COMMENTS TO NPDES PERMIT RENEWAL Gibraltar Rock Quarry, New Hanover Township

COMMENTS PRESENTED AT PUBLIC HEARING
MARCH 29, 2016

NEW HANOVER TOWNSHIP, MONTGOMERY COUNTY, PA

Toby J. Kessler, P.G. – Hydrogeologist
Gilmore & Associates, Inc.

Private Well Sampling Map

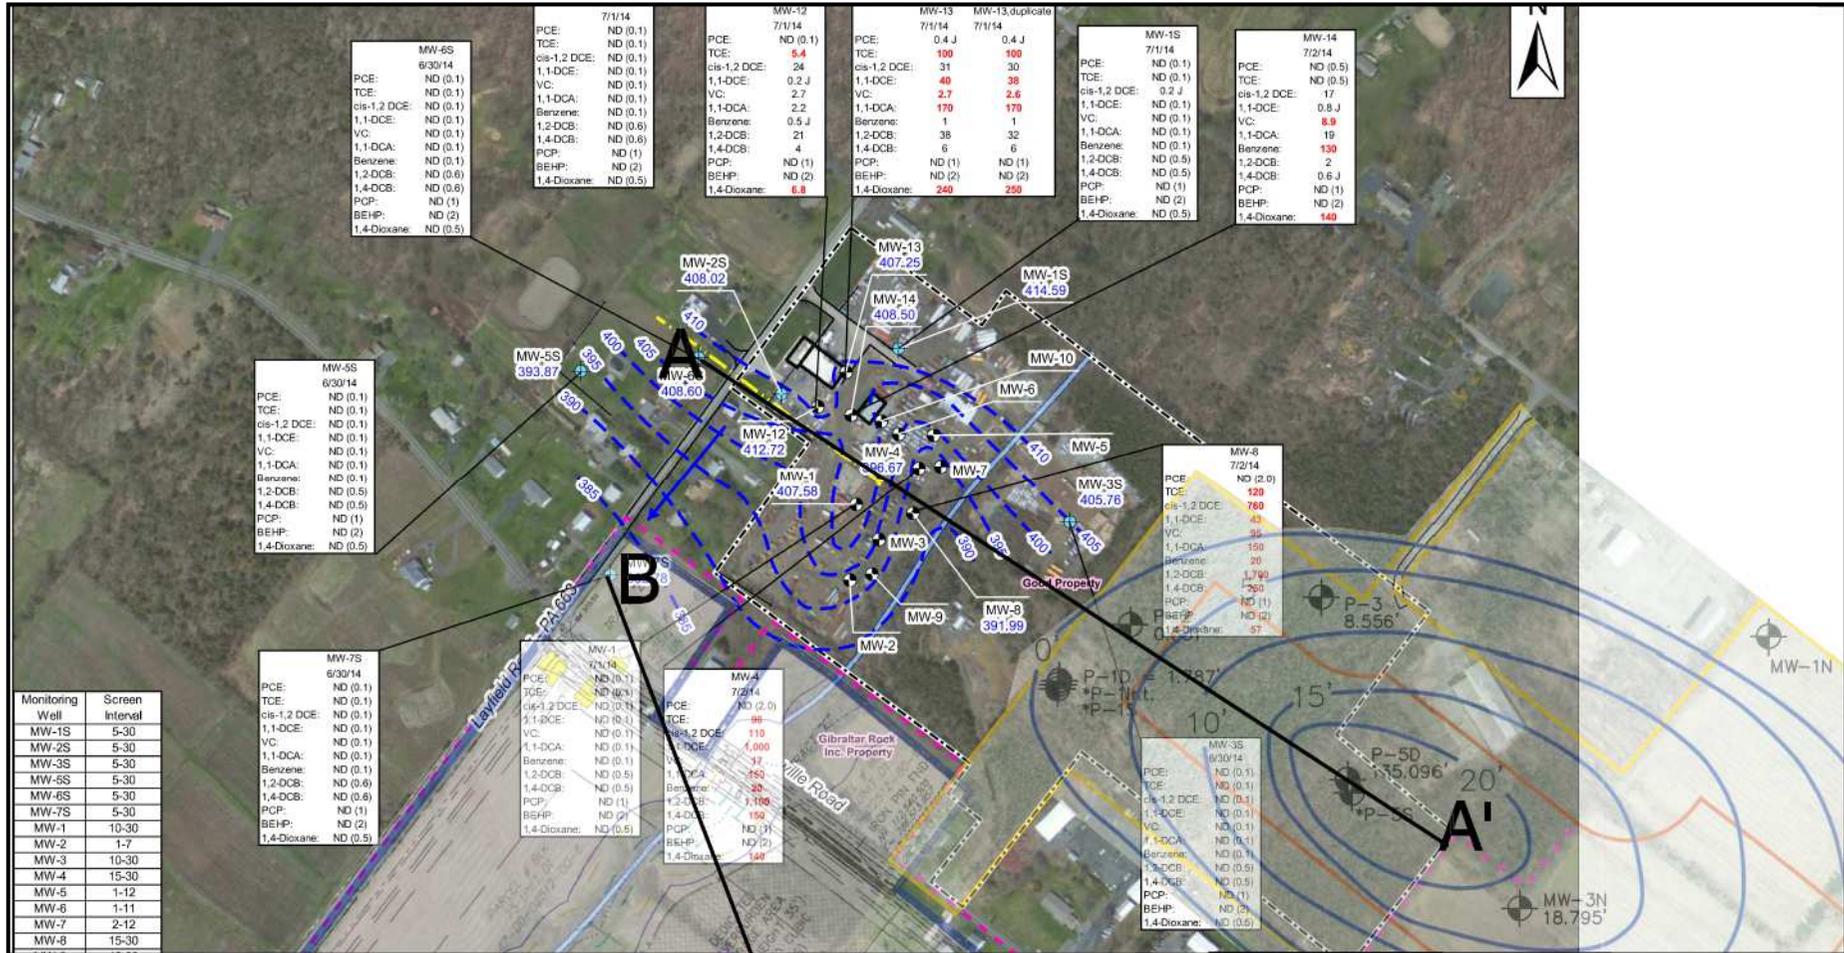
- **Private Well Sampling (2012-2013) is shown adjacent to areas proposed for Gibraltar Rock quarry.**
- **Properties with contaminated wells based on the sampling have been connected by PADEP to public water supply.**
- **No background sampling of private wells for Hoff VC site contaminants has been performed by Gibraltar in support of the NDPEs Permit Renewal.**

Conceptual Cross Sections

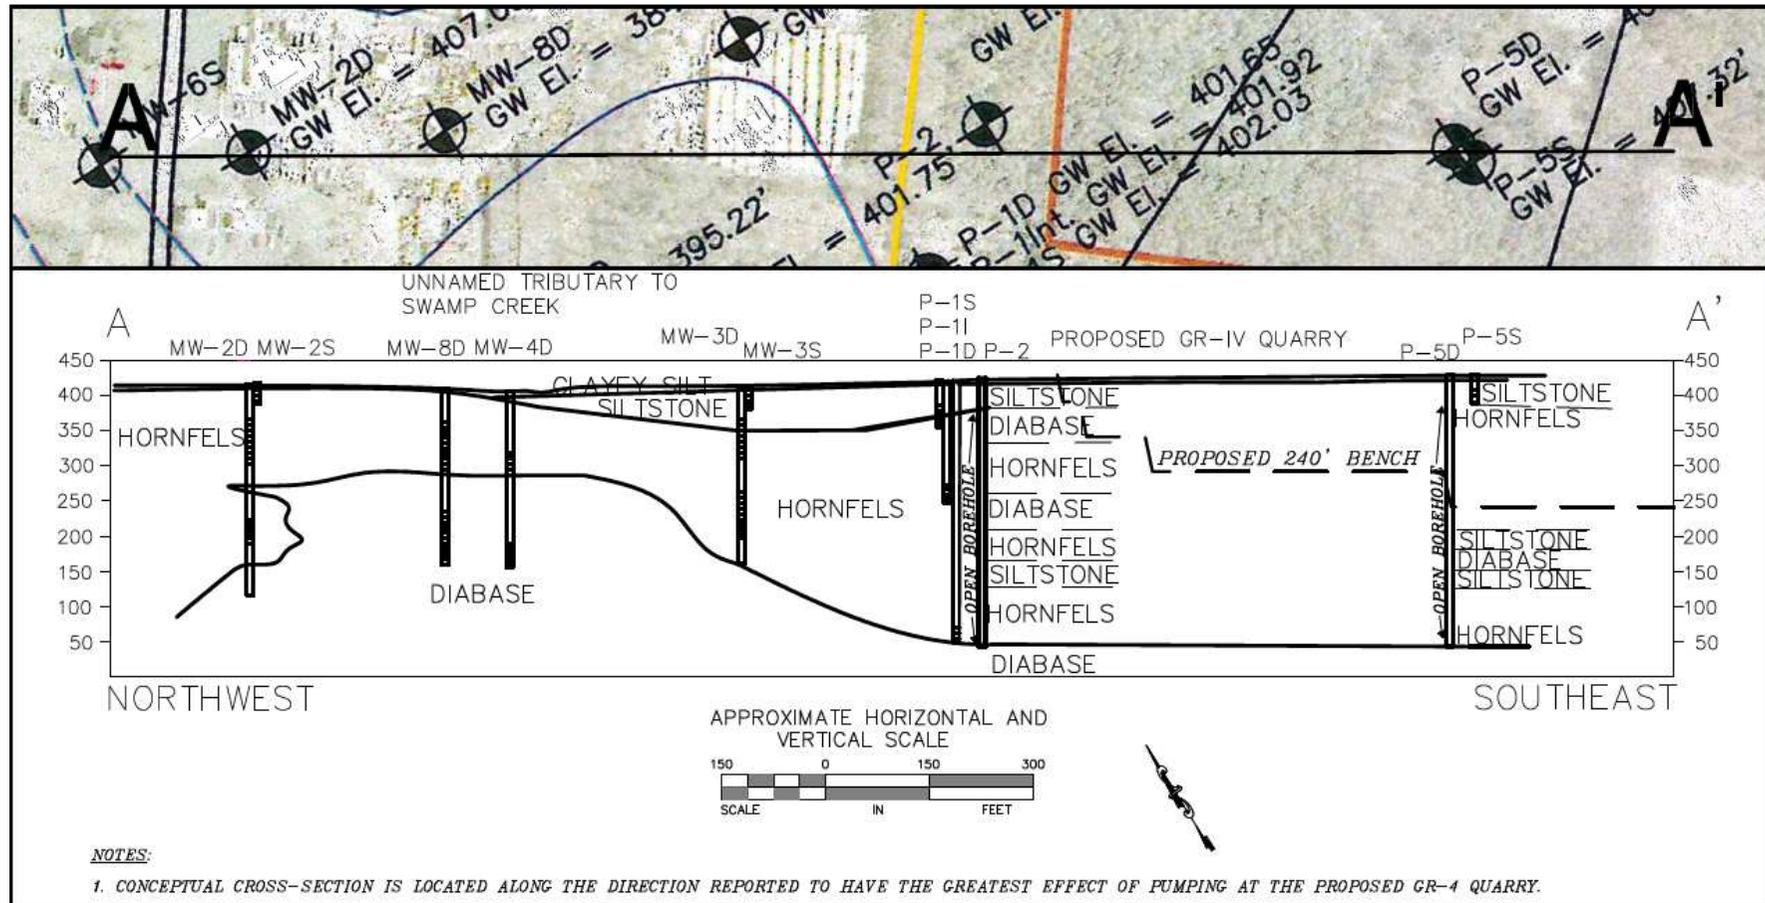
- **Conceptual Cross Sections are shown on the following slides that present potential pathways between the Hoff VC Site and GR Quarry.**
- **Cross Section A-A' trends along the direction reported to be most likely to be influenced by lowering of the water table in the GR-IV zoning application (2016).**
- **Cross Section B-B' trends along direction most likely to be influenced by lowering of the water table in the GR quarry application (2003).**
- **No fate and transport modeling was provided in the NPDES application.**
